# UNITED STATES PATENT AND TRADEMARK OFFICE

APPLICATION NO.	FILING DATE	FIRST NAMED INVENTOR	ATTORNEY DOCKET NO.	CONFIRMATION NO.
10/823,469	04/13/2004	Sanjeev M. Naik	GP-303757	4574

<b>Office Action Summary</b>	<b>Application No.</b> 10/823,469	<b>Applicant(s)</b> NAIK ET AL.	
	<b>Examiner</b> Lan Nguyen	<b>Art Unit</b> 3683

## DETAILED ACTION

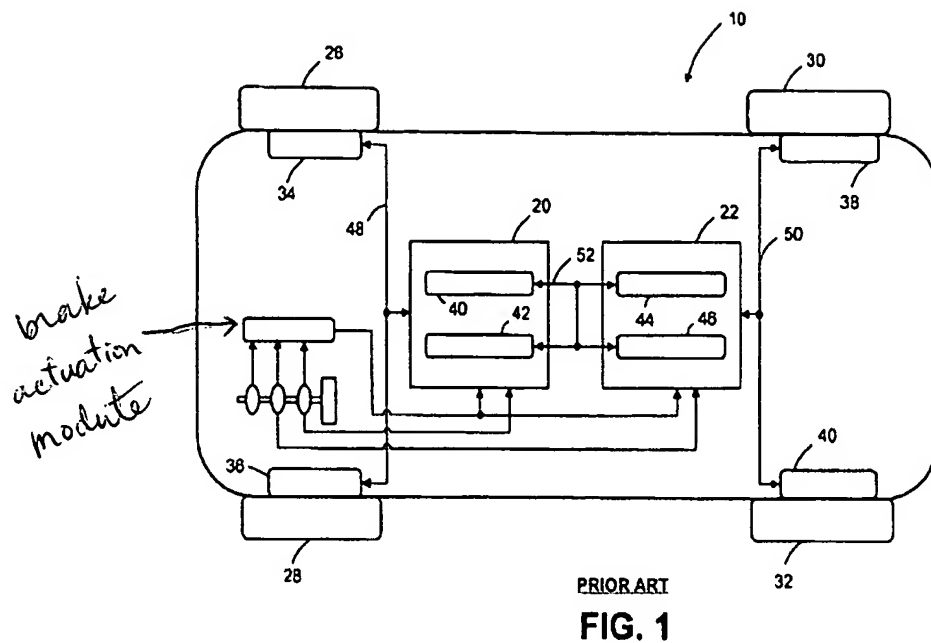
2. Claims 1-12, 14, 17 and 20-22 are rejected under 35 U.S.C. 103(a) as being unpatentable over Applicant's admitted Prior Art of Figure 1 in view of Kato et al. (USP 5,548,601).

Re: claim 1, Figure 1 of the admitted Prior Art teaches a brake control system, as in the present invention, comprising: a first pair of brake control units 34, 36; a second pair of brake control units 38, 40; a first brake control bus 48 which is operatively connected to each of the respective ones of said first pair of brake control units; a second brake control bus 50 which is operatively connected to each of the respective ones of said second pair of brake control units; a first supervisor controller 20 which is operatively connected to said first brake control bus and adapted to control each of the respective ones of said first brake control unit pair through said first control bus; a second supervisory controller 22 which is operatively connected to said second brake control bus and adapted to control each of the respective ones of said second brake control unit pair through said second control bus; a controller bus 52 which is operatively connected to each of said first supervisor controller and said second

supervisory controller; and a brake actuation module in signal communication and adapted to provide a brake signal to each of the first and second supervisory controllers as marked in figure 1 below. Figure 1 of the admitted Prior Art lacks a monitoring controller which is operatively connected to said controller bus and adapted to monitor the performance of said first supervisory controller, said second supervisor controller, said first brake control bus, and said second brake control bus. Kato et al. teach the concept of a monitoring controller 80, 85 which is operatively connected to said controller bus Td1, Td2 and adapted to monitor the performance of said first supervisory controller CPU1, said second supervisor controller CPU2, said first brake control bus Td1, and said second brake control bus TD2, as shown in figure 5 and column 7, line 30, in order to improve the ability to detect fault in a brake system to provide more reliable control to the brake system. Kato also shows monitoring controller 80, 85, first and second supervisor controllers CPU1, CPU2, each signally connected to a brake actuation module U in figures 1 and 3 of Kato. Kato further teaches in column 8, lines 8-12 that the monitoring controller is employed in actual slip control. It would have been obvious to one of ordinary skill in the art at the time the invention was made to have modified Figure 1 of the admitted Prior Art to include a monitoring controller such as taught by Kato in order to improve the ability to detect fault in a brake system to provide more reliable control to the brake system.

Re: claim 12, Figure 1 of the admitted Prior Art in combination with Kato shows said first supervisory controller and said monitoring controller comprise a first fail-silent pair and said second supervisory controller and said monitoring controller comprise a second fail-silent pair in that said monitoring controller is monitoring the performance of the first and second supervisory controller to detect abnormal condition and disabling

Re: claims 21 and 22, Figure 1 of the admitted Prior Art shows all the claimed features of claims 21 and 22.

Re: claim 14, Figure 1 of the admitted Prior Art shows a brake control system, comprising: a first pair of brake control units 34, 36, a second pair of brake control units 38, 40, a first brake control bus 48 which is operatively connected to each of the respective ones of said first pair of brake control units, a second brake control bus 50 which is operatively connected to each of the respective ones of said second pair of brake control units; a first supervisory controller 20 which is operatively connected to said first brake control bus and adapted to control each of the respective ones of said first brake control unit pair through said first control bus; a second supervisory controller 22 which is operatively connected to said second brake control bus and adapted to control each of the respective ones of said second brake control unit pair through said second control bus; a controller bus 52 which is operatively connected to each of said first supervisory controller and said second supervisory controller; a brake actuation module in signal communication and adapted to provide a brake signal to each of the first and second supervisory controllers as marked in figure 1 above. Figure 1 of the admitted Prior Art lacks the monitoring controller and a cut off module as claimed. Kato et al. teach and a monitoring controller 80, 85 which is operatively connected to said controller bus and adapted to monitor the performance of said first supervisory controller, said second supervisory controller, said first brake control bus, and said

controller as amended. Applicant further argues that Kato does not teach the monitoring controller to be in signal communication and adapted to receive a brake signal from a brake actuation module. Applicant is correct in that admitted Prior Art of figure 1 lacks the brake actuation module to be in signal communication and adapted to provide a brake signal to the monitoring controller. Kato is relied upon to cure the deficiency of the admitted Prior Art of figure 1 with the teaching of the use of a monitoring controller in order to monitor fault in the brake system. Kato shows that the monitoring controller is in signal communication and receiving brake signal from a brake actuation module U since the monitoring controller would be employed in an actual slip control. In other words, the fault information from the monitoring controller is used to ensure that the brake would operate in a most efficient way during a slip or ABS control process wherein the brake pressure is being controlled in order to prevent a vehicle from skidding. Hence, it is maintained that Kato does teach a brake actuation module in signal communication and adapted to provide a brake signal to the monitoring controller as stated above. The rejection has been modified to meet the amended portion.
